Video Products Technical Bulletin 30-2003-151

DATE: **August 11, 2003**SUBJECT: **REUSE IC101 WHEN REPLACING THE A BOARD**MODEL: **PVM-1353MD**
PVM-1453MDSERIAL NO: **ALL**

Figure 1

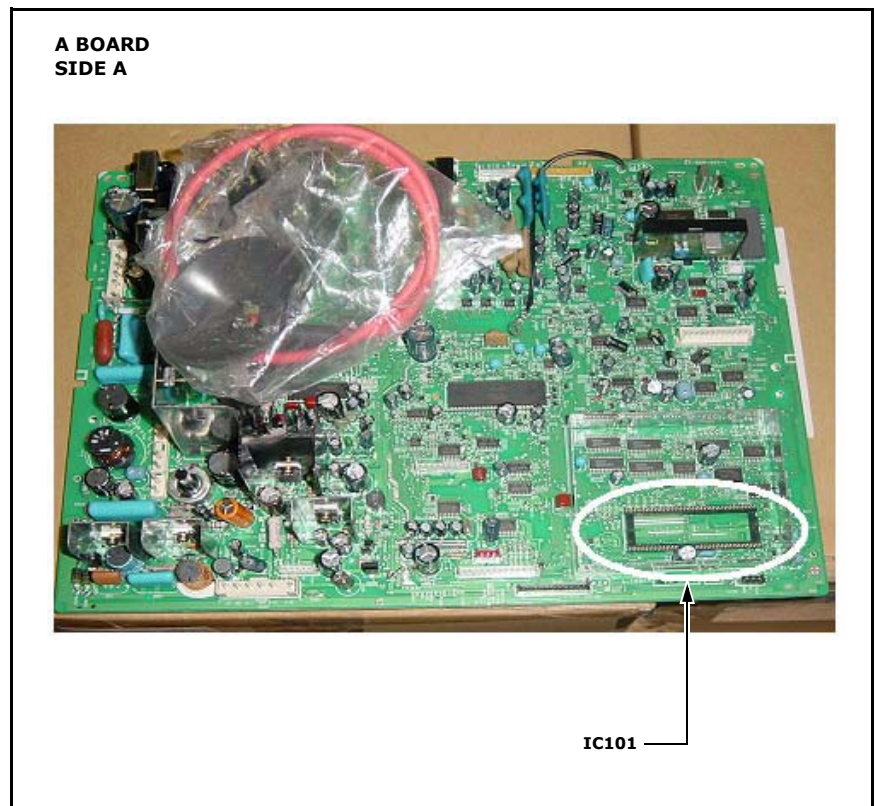
The new A board does not contain IC101, and IC101 is no longer available as a service part. (See Figure 1.)

When replacing the A board (A-1297-469-A), remove IC101 (8-759-399-23) from the former board and install it on the new board.
